Jersey Wharf – Jersey Street Ancoats
Design and Access Addendum
February 2024

PRP architects have been appointed by Manchester Life Development Company 3 limited and John Sisk and Sons Contractor to update the planning application for Jersey Wharf through a Minor Material Amendment (Section 73). The previous planning application reference is 133769/FO/2022 (as amended by 136201/NMC/2023).

The purpose of this Design and Access Addendum is to describe and highlight the proposed changes to the design. This document should be read in conjunction with the planning drawings that are being re-submitted, which are listed at the end of this document.

PROPOSED WASTE STORAGE STRATEGY DIAGRAM

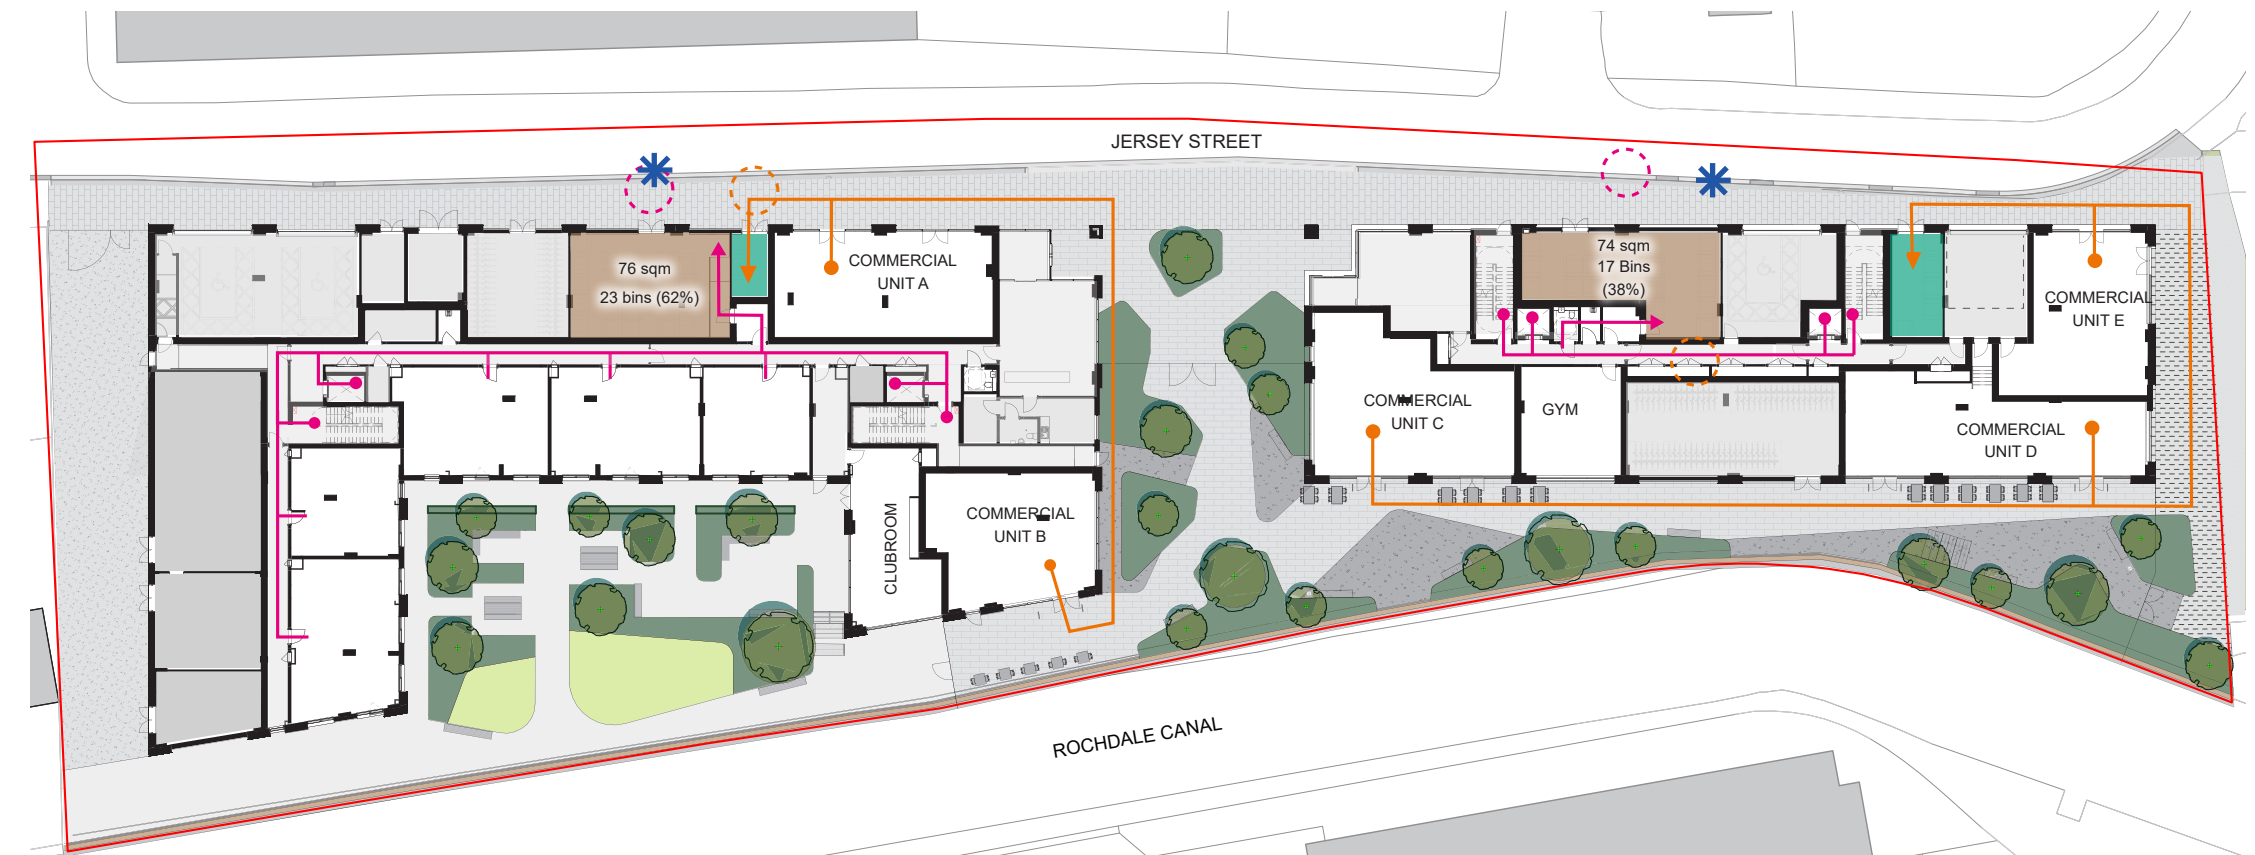
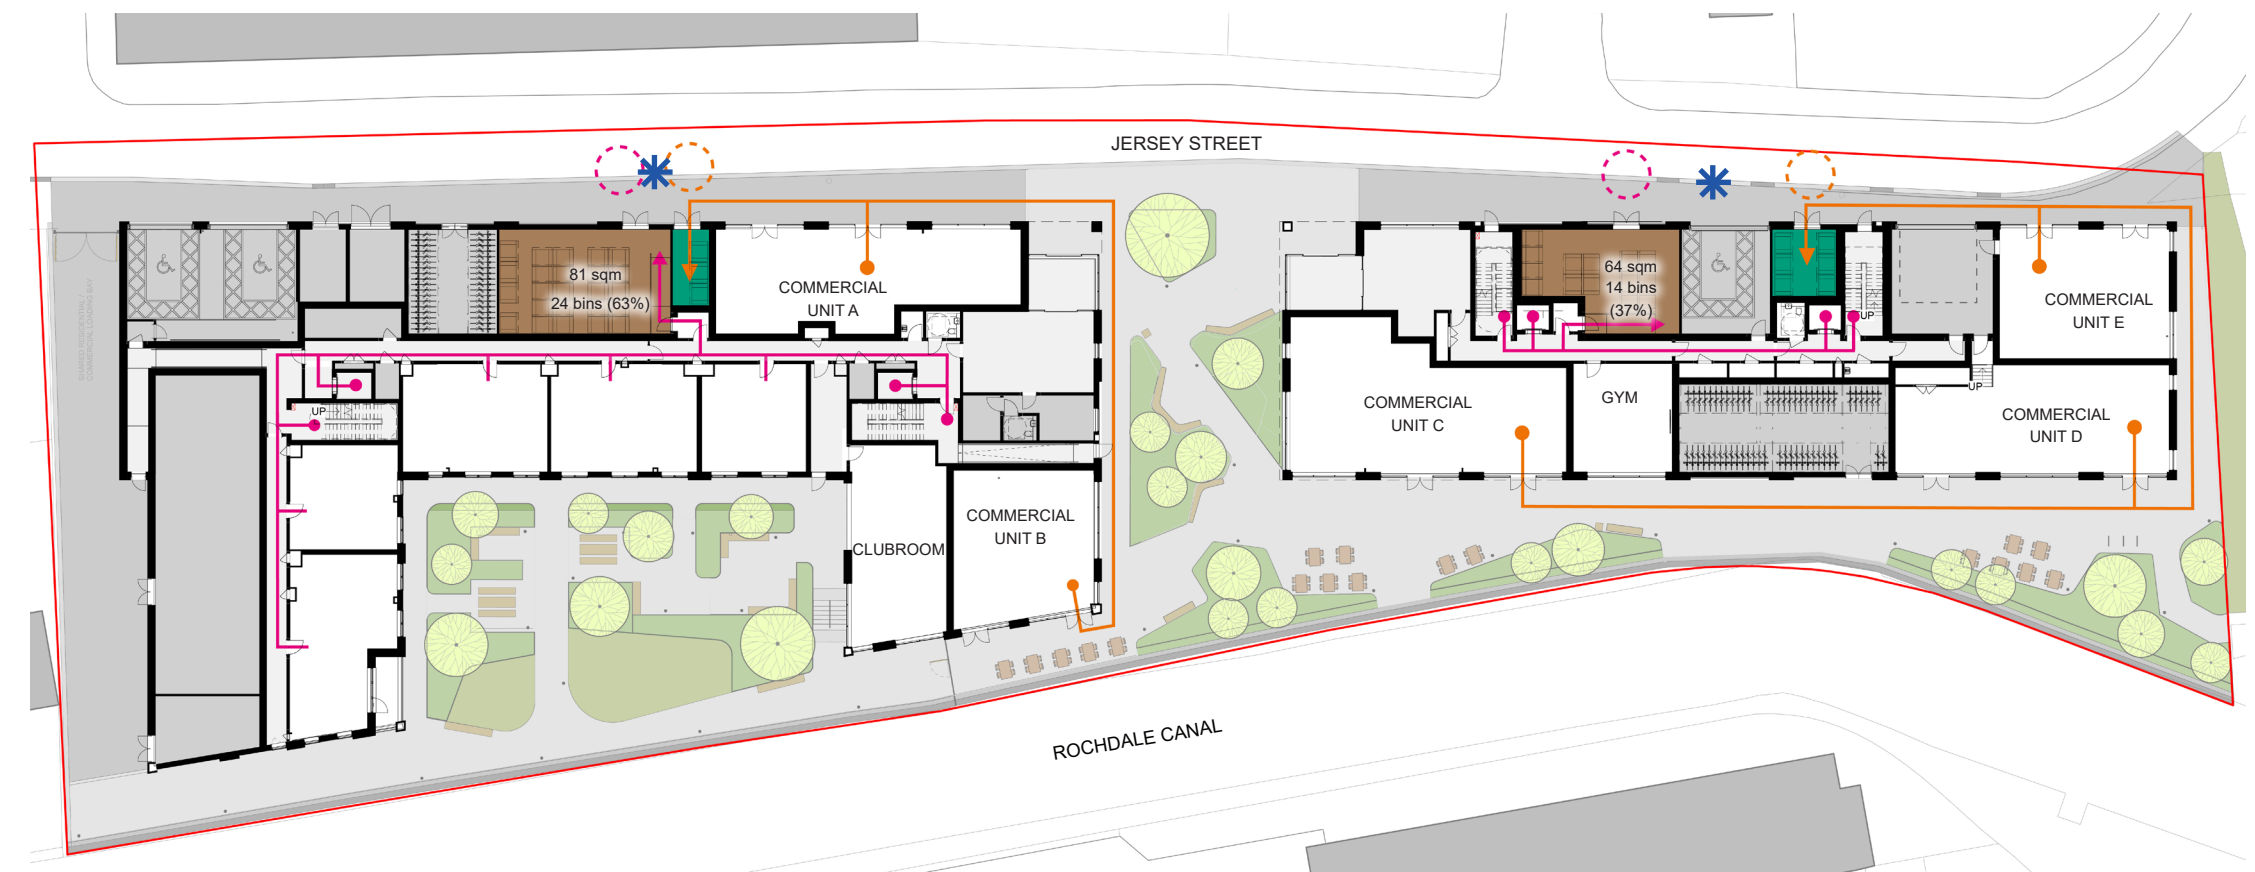
Waste storage provision has remained largely unchanged from the previous scheme design as the total number of apartments remains the same at 190 units.
